June 14, 2017

### NOTICE OF ADDENDUM ADDENDUM NO. 2

# CONTRACT NO. 7726 POLICE DEPARTMENT MIDTOWN DISTRICT CITY OF MADISON WISCONSIN

A810

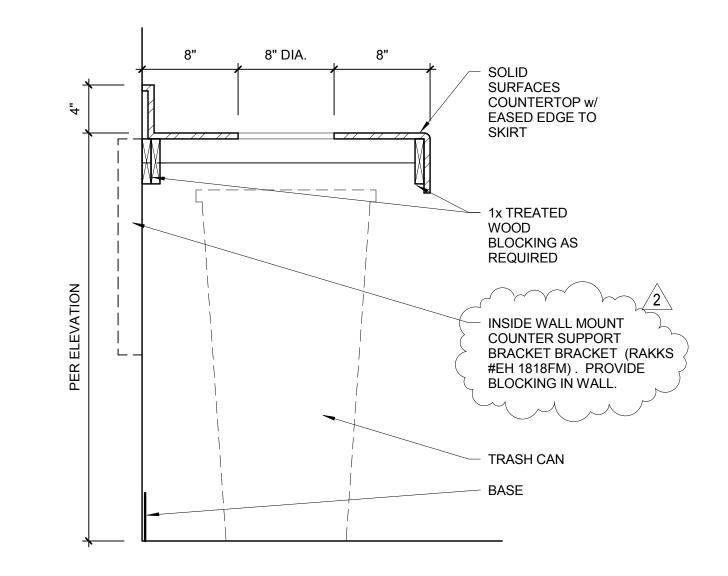
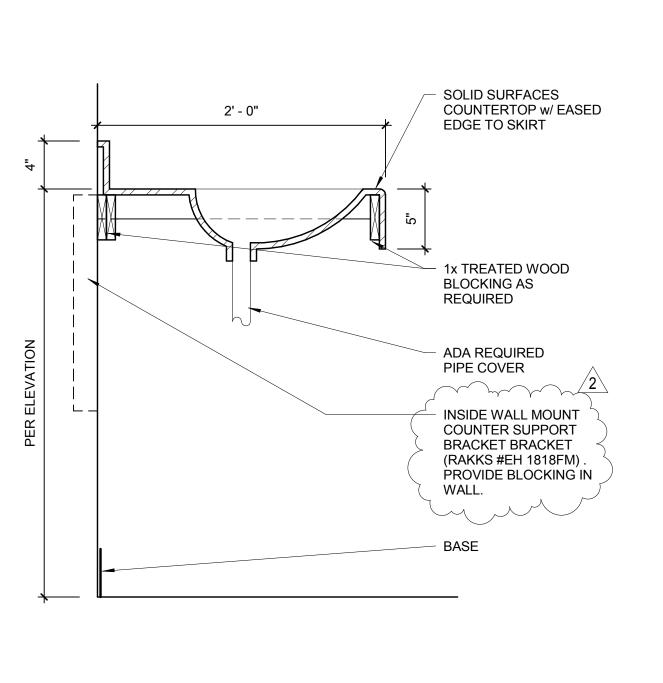
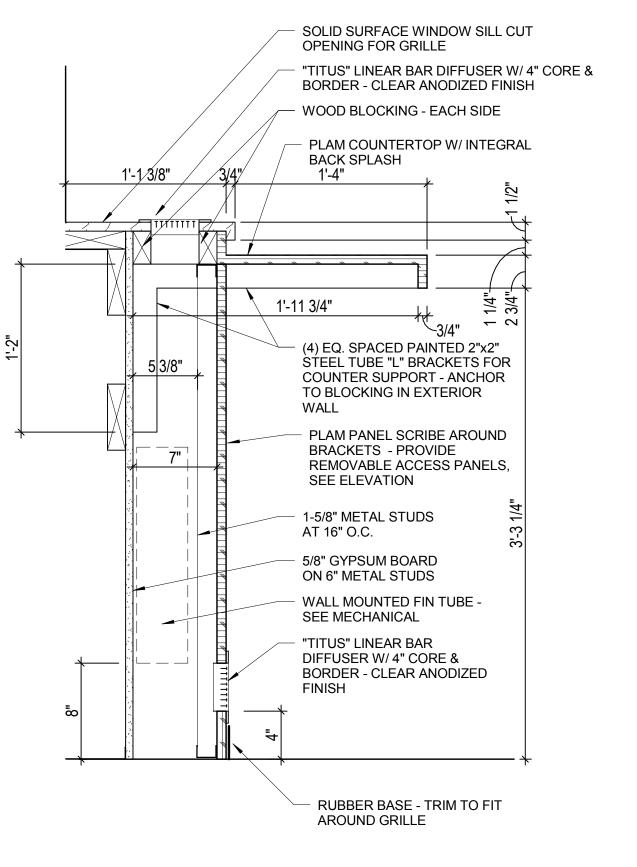
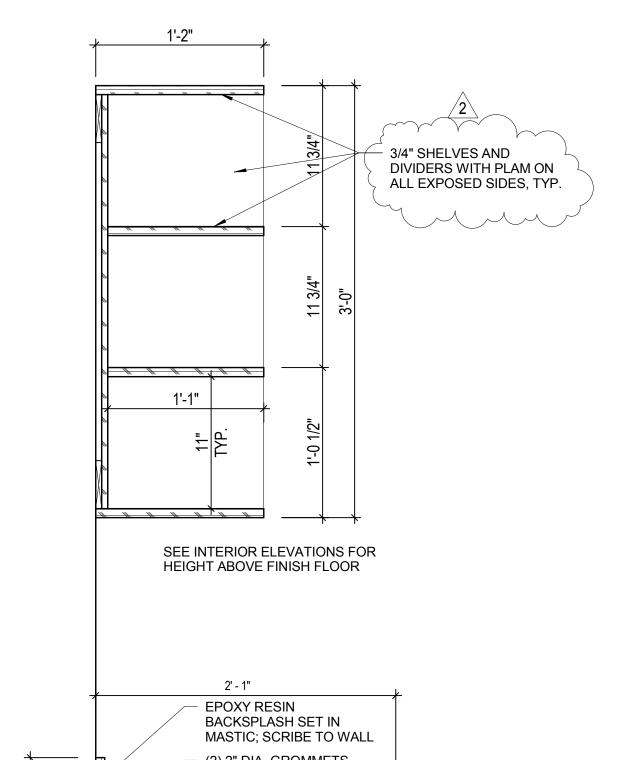
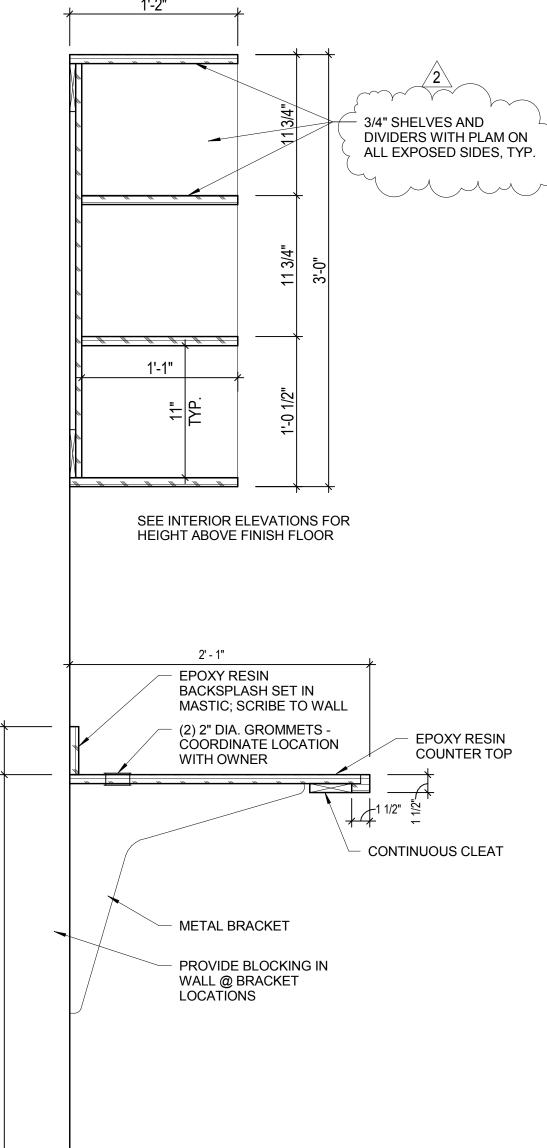
**Drawing A810:** Reference to plywood for shelving and dividers in multiple details have been removed. Reference to treated wood blocking in Detail 4 has been removed. Additional trim piece between doors in detail 6 has been removed. Refer to attached drawing.

CASEWORK SECTIONS & DETAILS

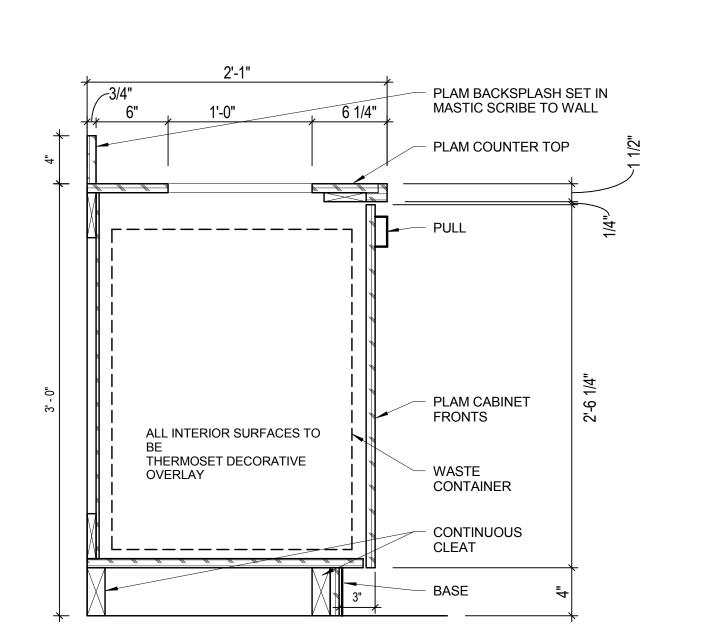
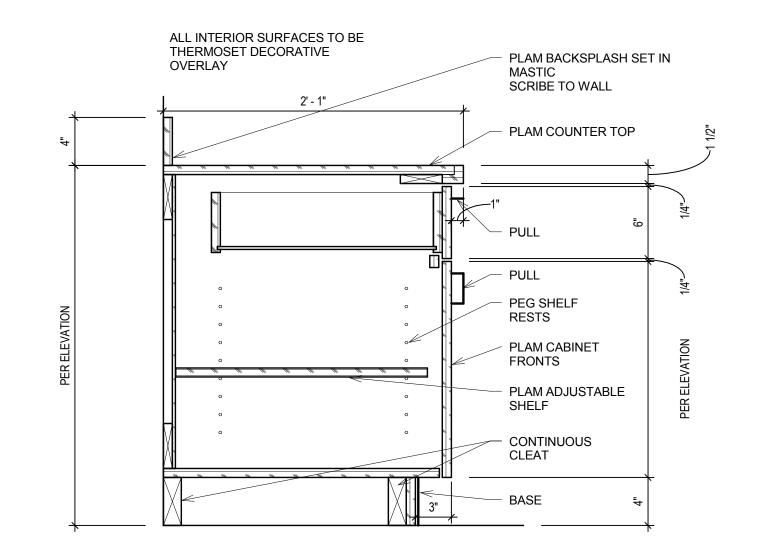
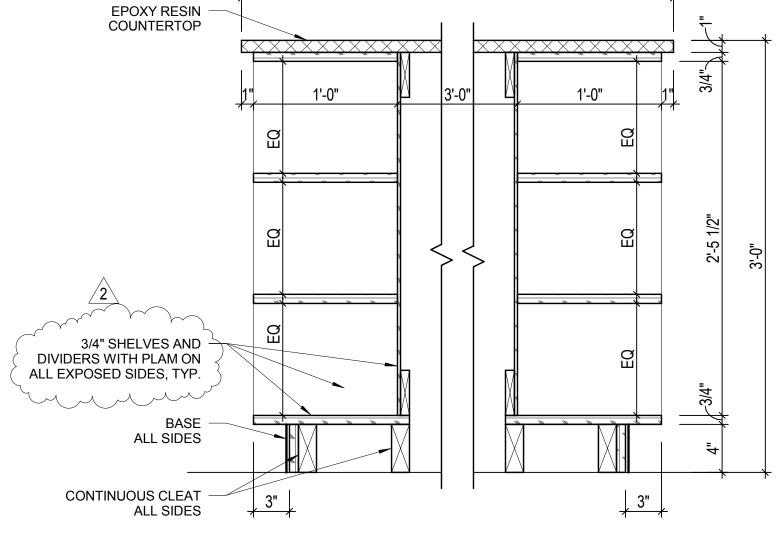
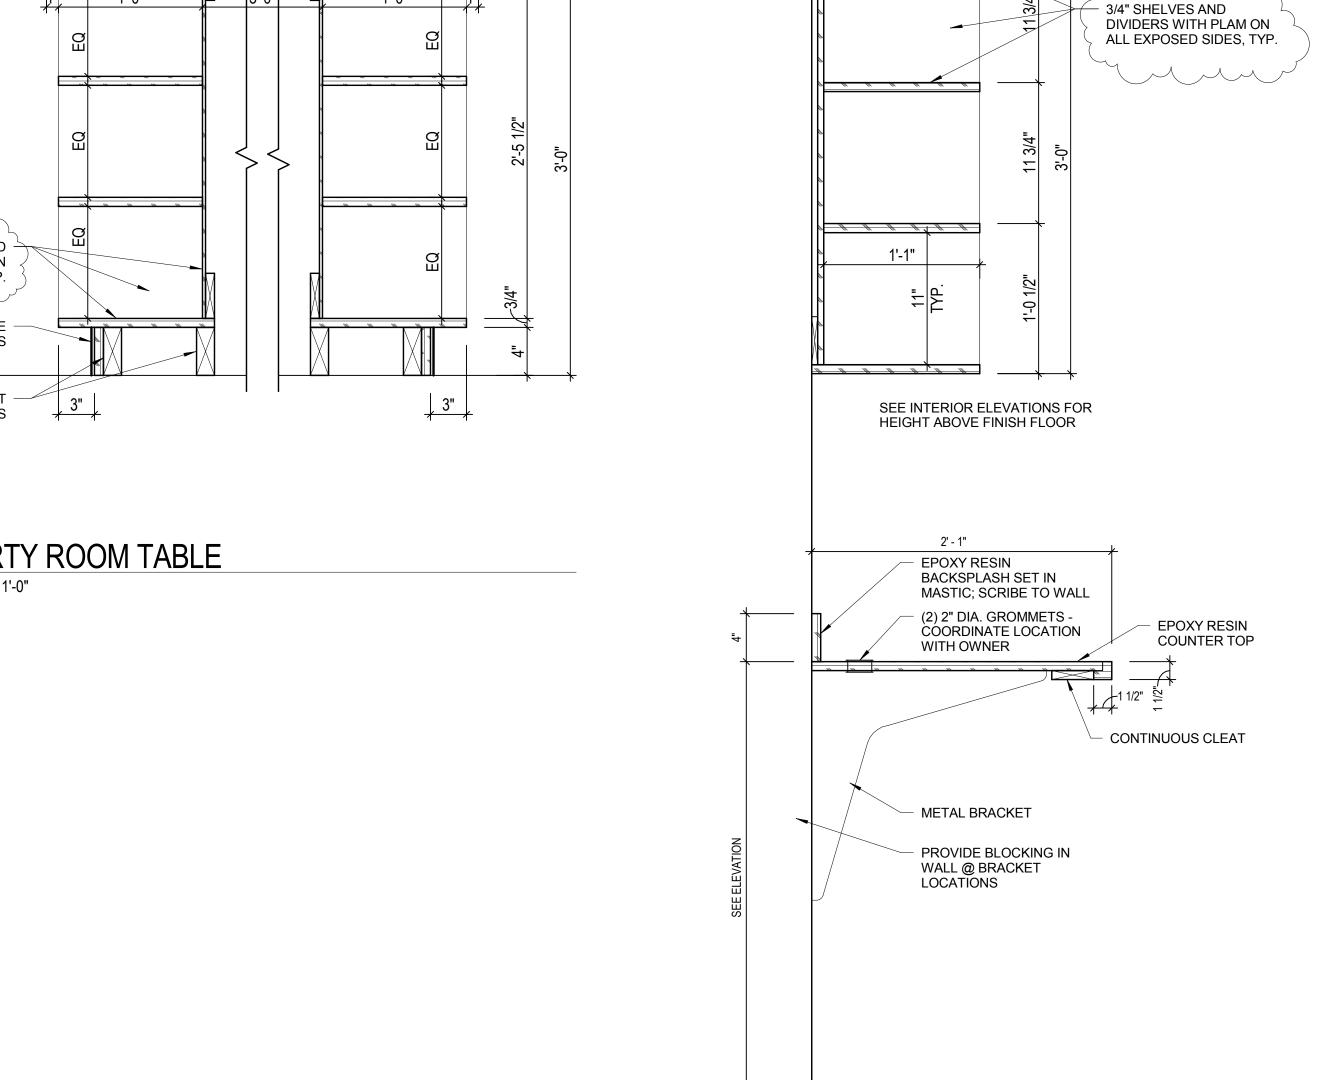
**Drawing A811:** Reference to plywood for shelving and dividers in multiple details have been removed. Plastic laminate support bracket in details 2 & 3 have been changed to be inside wall mount counter support bracket. Refer to attached drawing.

SCHEDULES -**MECHANICAL**

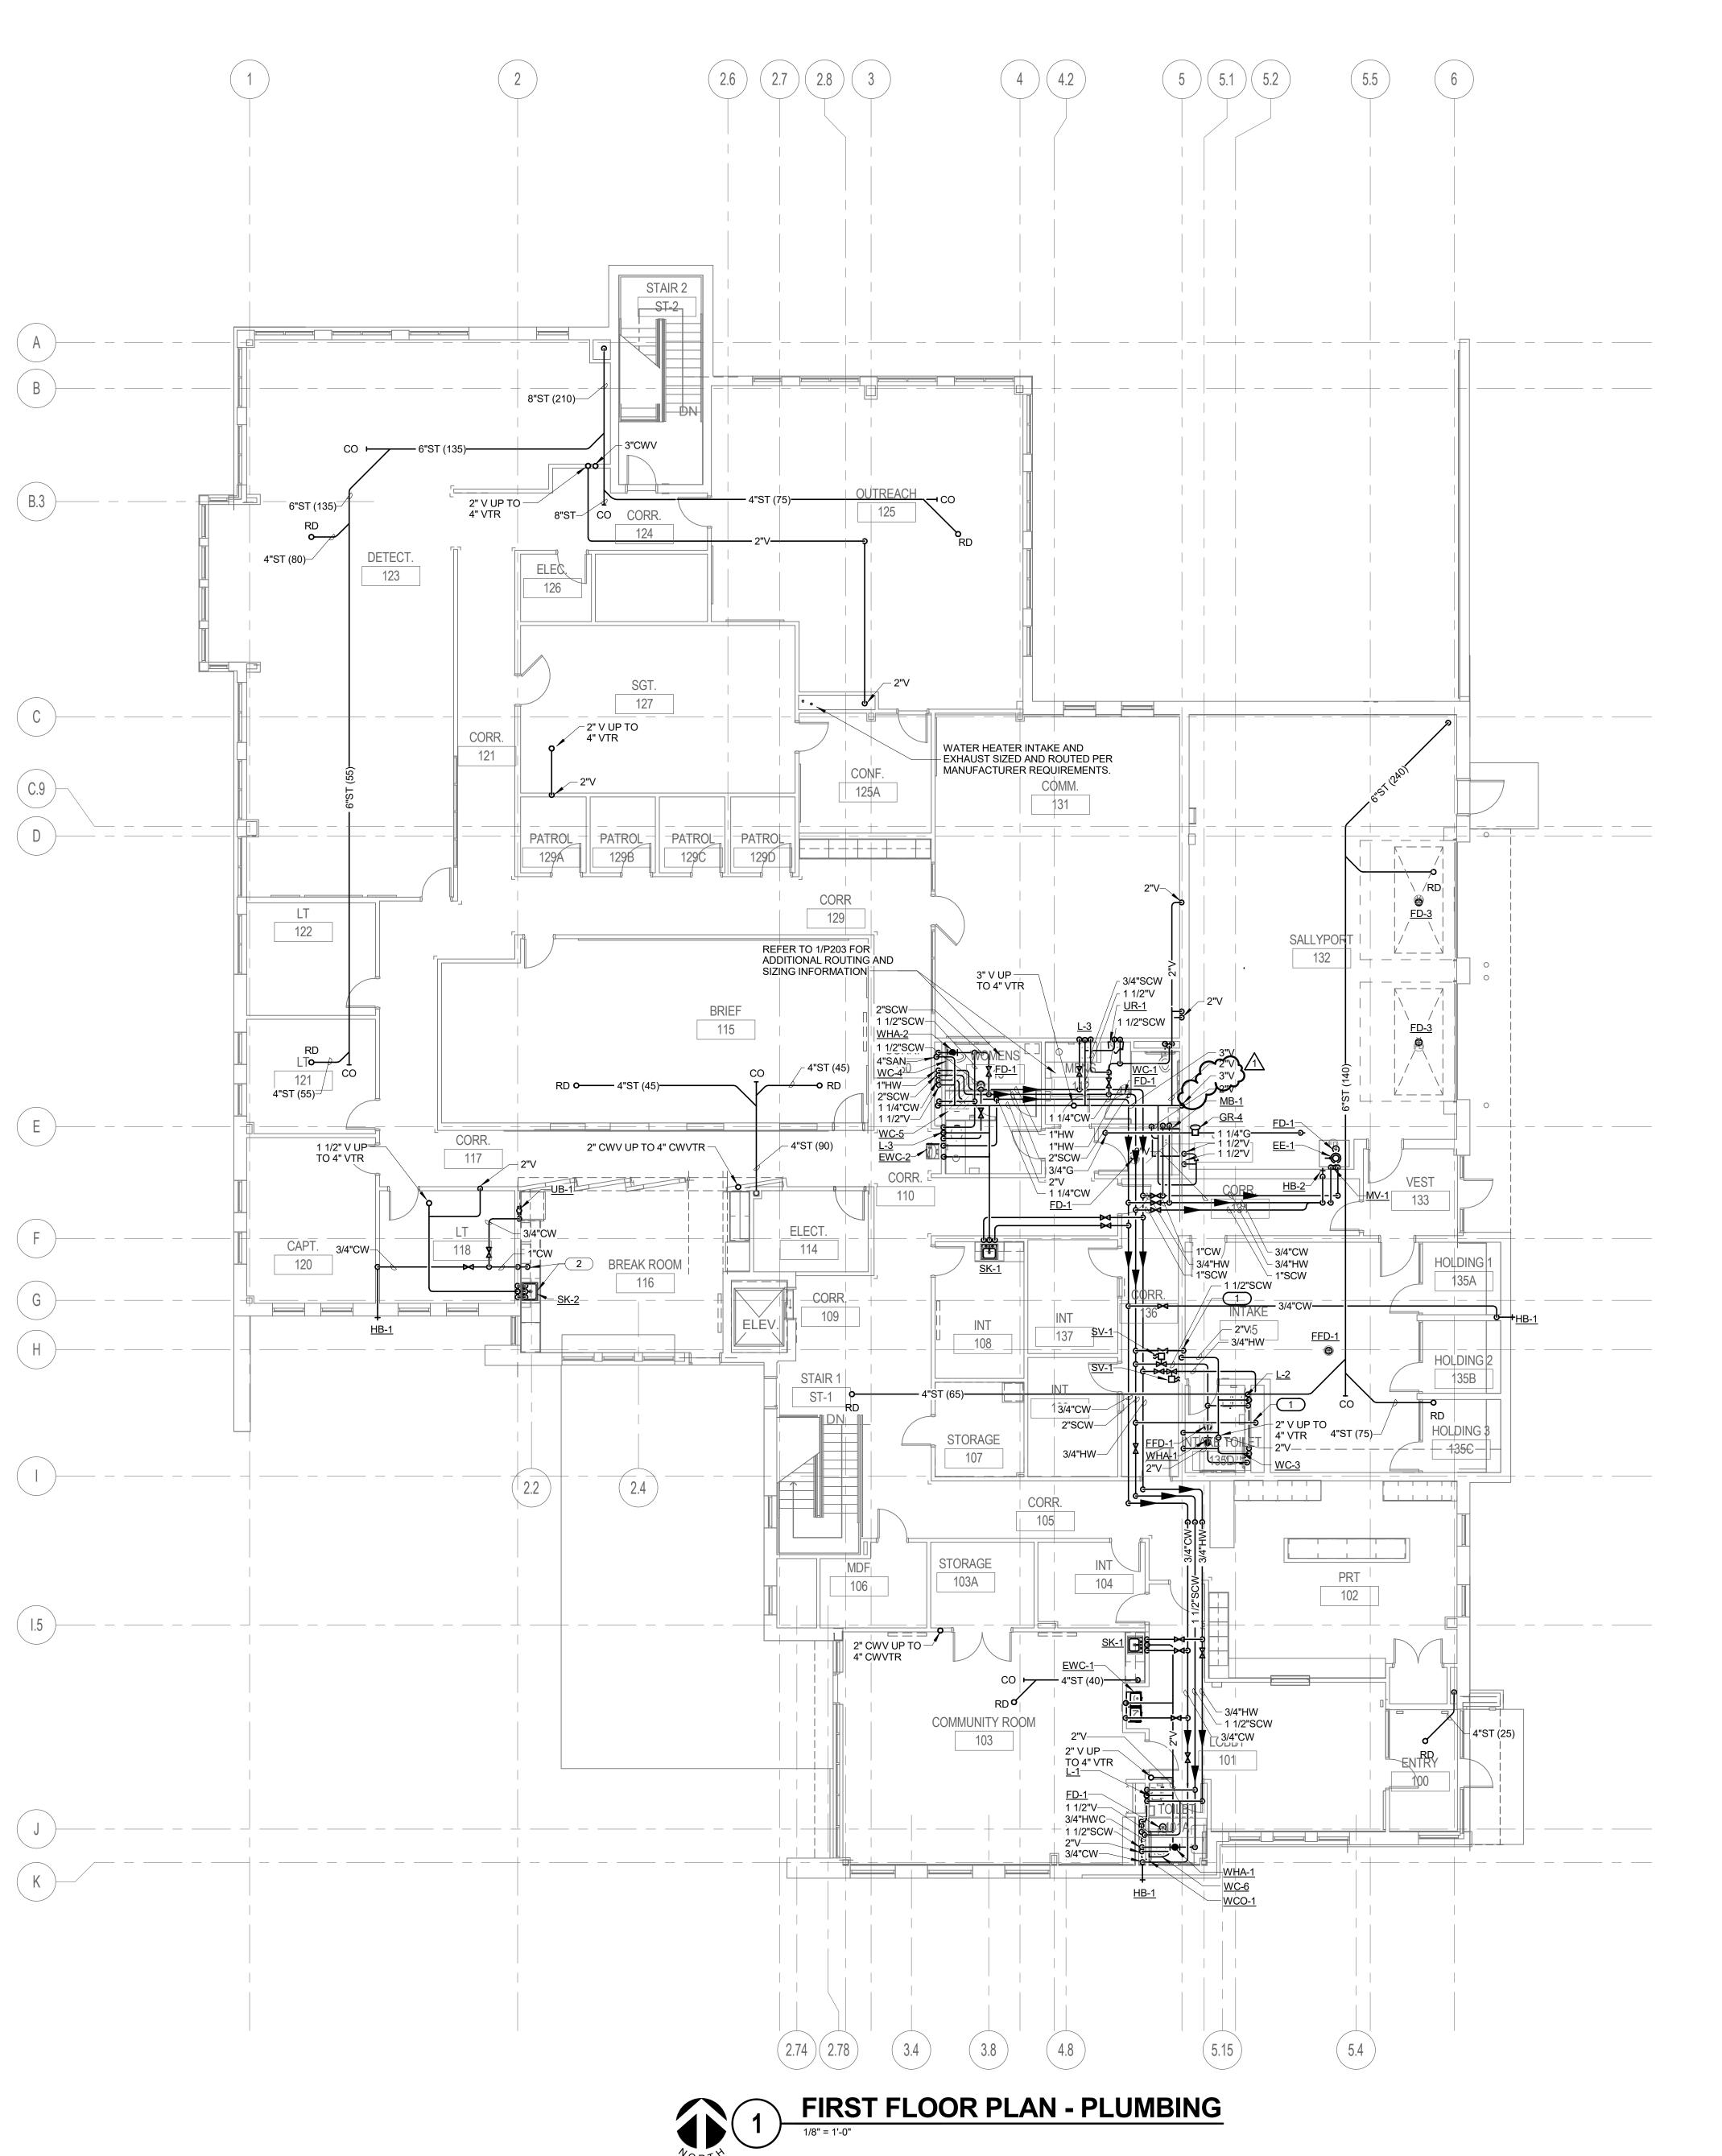
**Drawing M601:** Revise diffuser schedule. Refer to attached drawing for details.
